Errata and Added Information to MC68360 Quad Integrated Communication Controller User's Manual Rev 1

January 8, 1998

This document describes the latest information and changes to the first revision of the MC68360 user's manual.

Figure 6-6A External Components for 4.192MHz

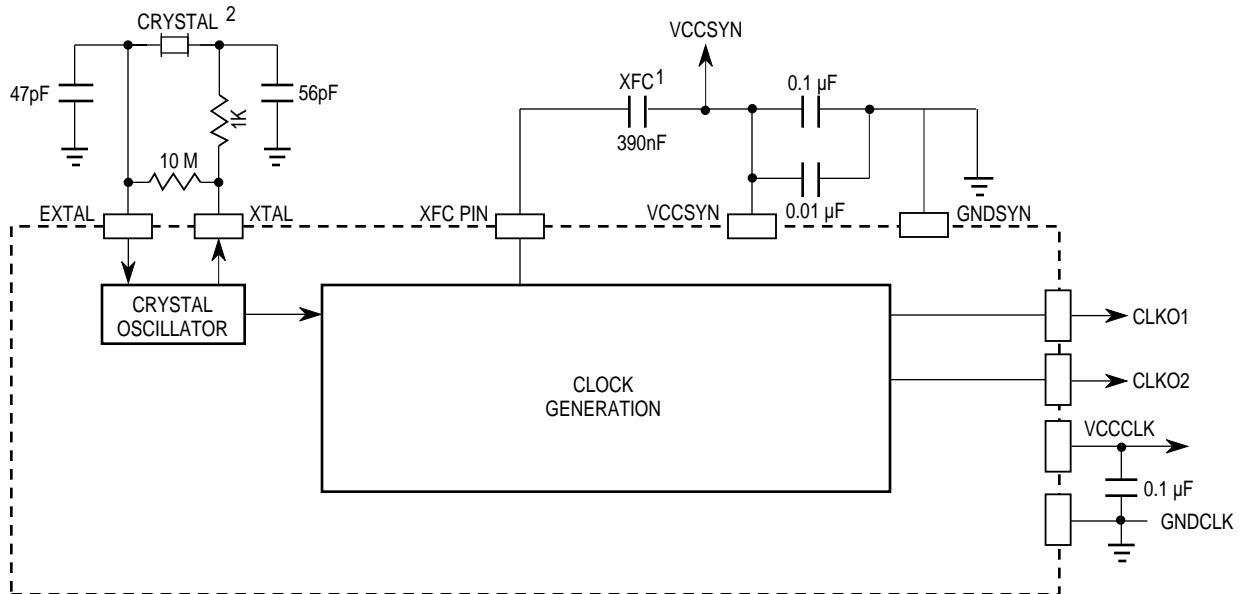
Also on page 6-14 the following figure should be added.

1. Must be low-leakage capacitor. See Section 10 Electrical Characteristics for recommended values.
2. Values are for 4.194MHz crystal and may vary due to capacitance on PCB.

Figure 10-44(b) MC68040/EC040 SRAM Write cycle (TSS40=0, CSNT40=1)

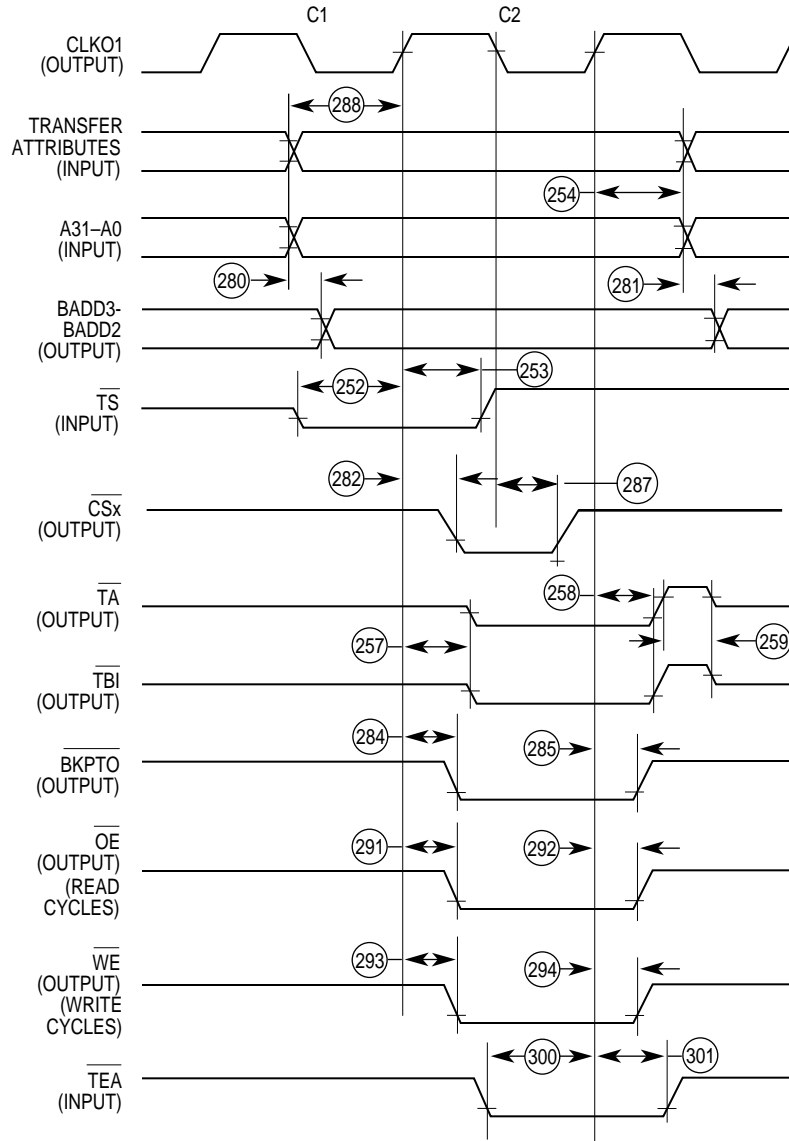
The following figure should be added after figure 10-44(a)

NOTE: MC68040 Transfer Attribute Signals = SIZx, TTx, TMx, R/W, LOCK

Figure 10-45(b) MC68040/EC040 SRAM Read Cycle (TSS40=1, CSNT40=1)

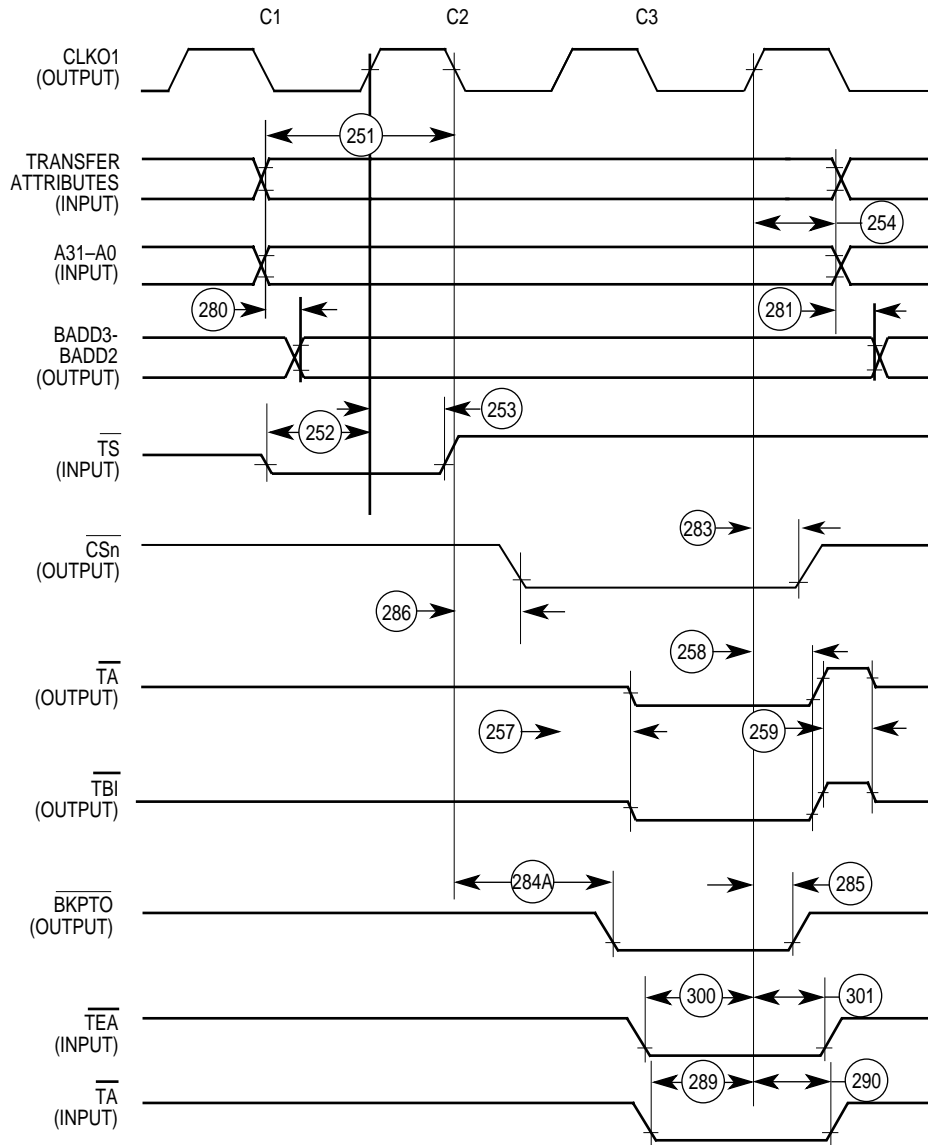
The following figure should be added below figure 10-45(a)

NOTE: MC68040 Transfer Attribute Signals = SIZx, TTx, TMx, R/W, LOCK
OE and WE are not supported when TSS40 is set to 1
